STAFF RECOMMENDATION

2804 Oakland Avenue

June 16, 2021

Application: New Construction—Addition and Outbuilding/Detached Accessory Dwelling Unit

Figure 3. 1957 Sanborn map.

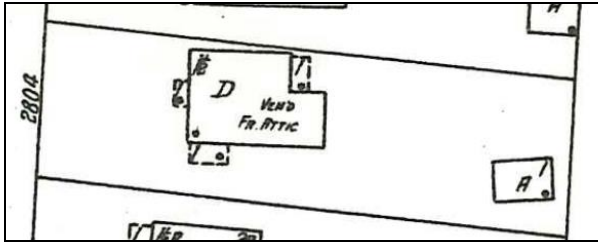
Partial Demolition: The plan includes the demolition of an existing upper-level door and exterior stairs on the right-side façade (Figure 2). The 1957 Sanborn map indicates that the house was a single-family home at the time (Figure 3). Since the door and exterior stairs were added after 1957, staff finds removal of these elements to be appropriate and to meet the design guidelines. No other changes are proposed to the historic house.

Staff finds the partial demolition to meet Section V.2 for appropriate demolition and to not meet Section V.1 for inappropriate demolition.

SITE PLAN

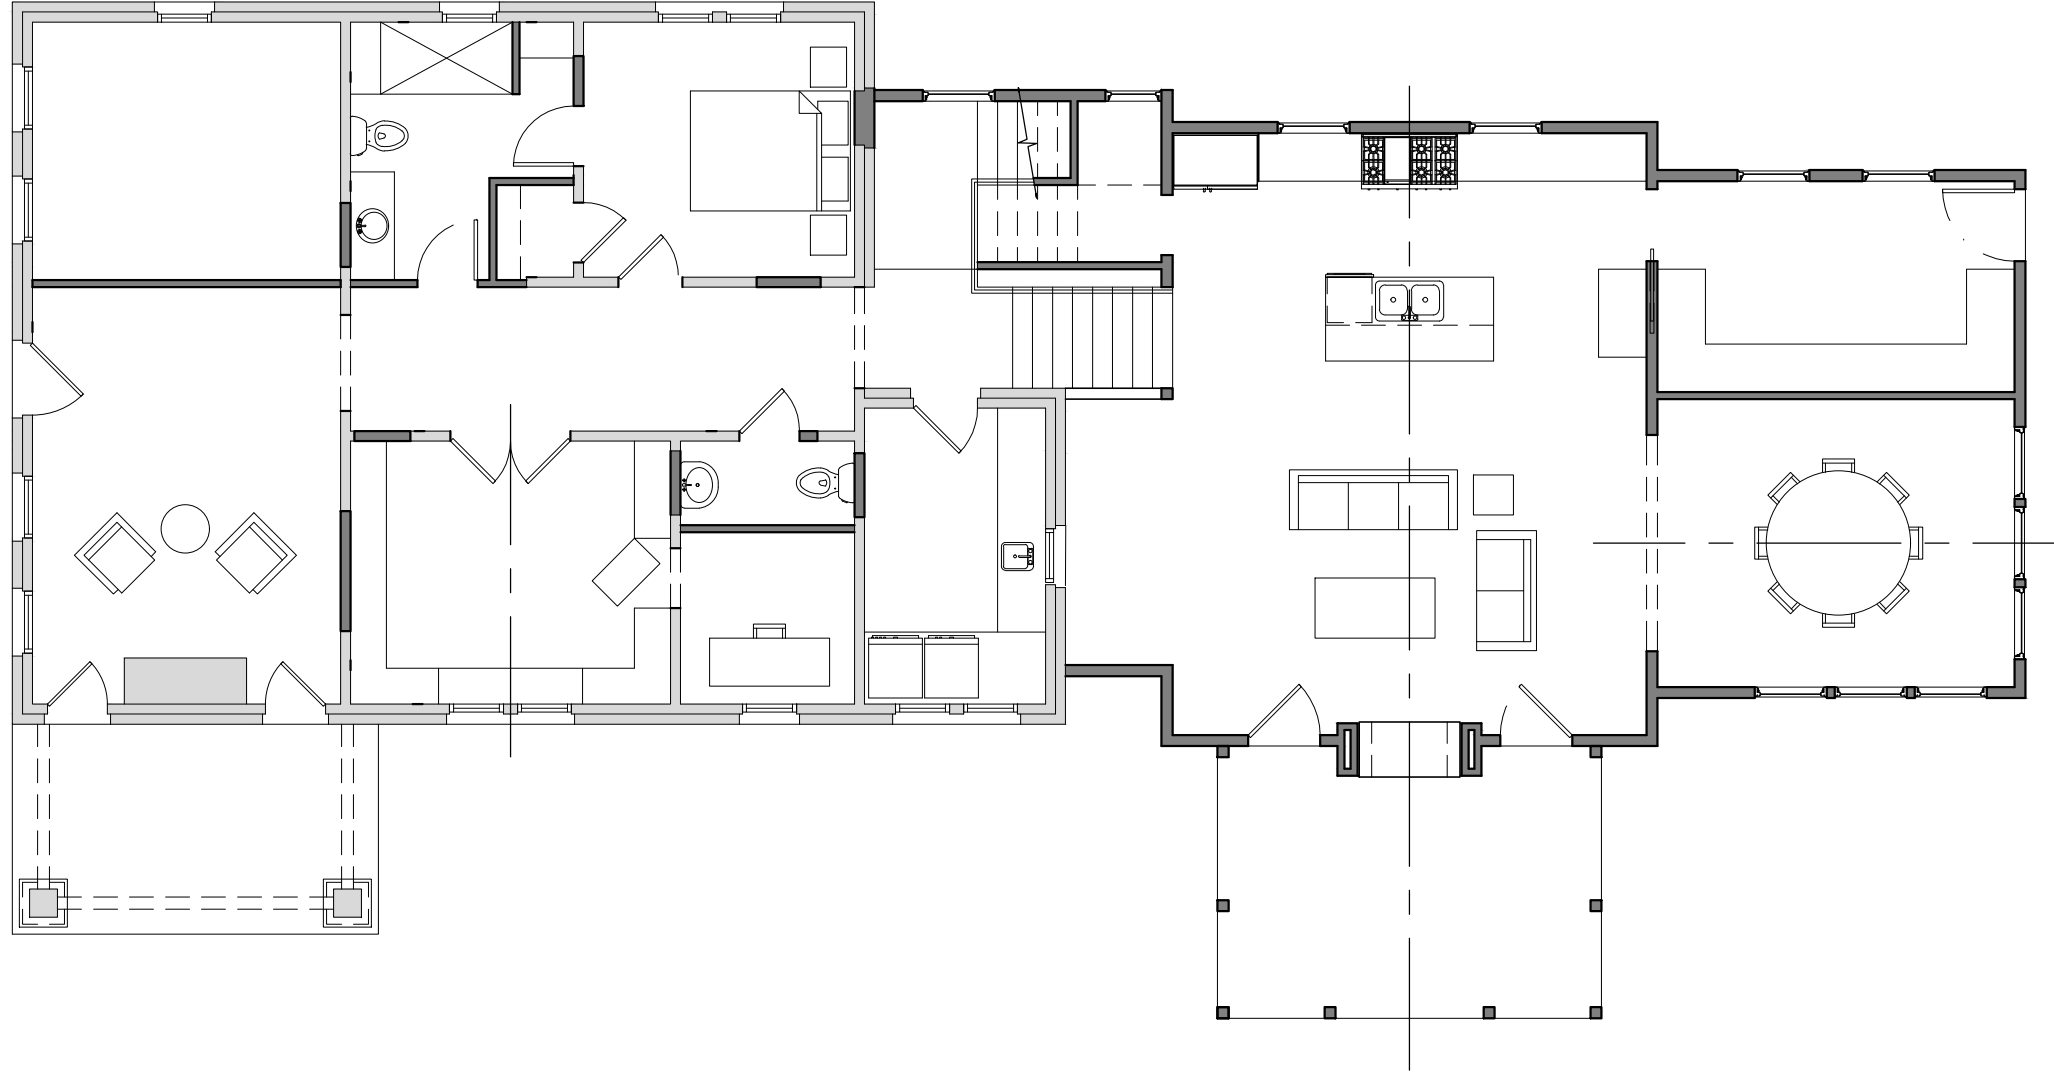
Setback & Rhythm of Spacing: The proposed addition meets all bulk zoning setbacks. The new construction is located five feet, ten inches (5'-10") from the right-side property line, five feet (5') from the left side property line, and approximately forty-seven feet (47') from the rear property line.

The project meets Section II.B.1.c.

ELEVATIONS

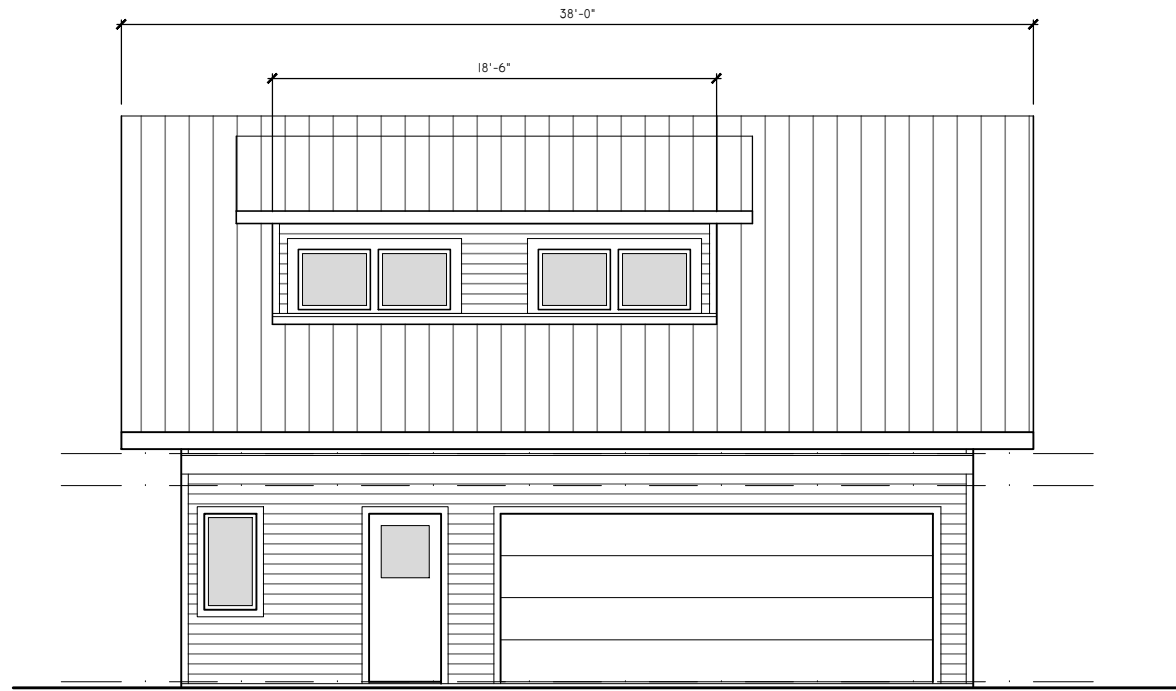
Height & Scale: The proposed rear addition is a one and one-half story addition to a one and one-half story historic house. The addition incorporates a ridge raise and utilizes the change in grade to step down the floor level. The eaves on the addition are approximately two feet (2') taller than the historic house, but staff finds that it could be appropriate in this case since the addition still reads as a one and one-half story addition to a one and one-half story house. The proposed addition does not more than double the existing footprint. The new construction adds approximately one thousand, two hundred, fifty-three square feet (1253 sq. ft.) to the existing footprint of one thousand, three hundred, twenty-five square feet (1325 sq. ft.).

The new construction incorporates a ridge raise which can be appropriate since the house has a side gable roof form. The proposed ridge is set in two feet (2') from the existing side walls and eaves and extends two feet (2') taller than the historic house, which meets the design guidelines.

The addition sets in a minimum of three feet, eight inches (3'-8") from the left rear corner for the full depth of the addition and two feet (2') from the right rear corner. On the right-side, the addition goes back four feet (4') before coming out approximately three feet, six inches (3'-6") wider than the existing side porch. When rear additions extend wider than an historic house, the required structural alcove is supposed to be twice as deep as it is wide in order to meet the design guidelines. Staff finds that a wider rear addition can be appropriate in this case since the primary massing of the historic house is approximately thirty feet (30') wide and shifted to the left side of the lot. In addition, the portion of the addition that extends wider is a single-story covered porch that will appear to sit lower than the existing covered side porch given the site's change in grade.

Roof Form: The addition incorporates a ridge raise that meets the design guidelines. On the right-side, the ridge raise sits atop the existing rear gable piece which sits below the

main ridge. On the left-side the ridge raise ties into a flat connector that connects to the rest of the rear addition. While this design is atypical, it allows for the rear gable, which is original to the house, to be preserved. The ridge raise then ties into a rear gable that ties into another rear gable as the addition steps in further. Both rear gable portions have a pitch of approximately 8/12 incorporate shed dormers that are inset appropriately.

Proportion and Rhythm of Openings: The windows on the proposed addition are all generally twice as tall as they are wide, thereby meeting the historic proportions of openings. There are no large expanses of wall space without a window or door opening. Staff finds the project’s proportion and rhythm of openings to meet Section II.B.1.g.

With staff approval of the final selections of the roof color, doors, driveway material, side porch elements, and rear balcony elements prior to purchase and installation, staff finds that the project meets Section II.B.1.d
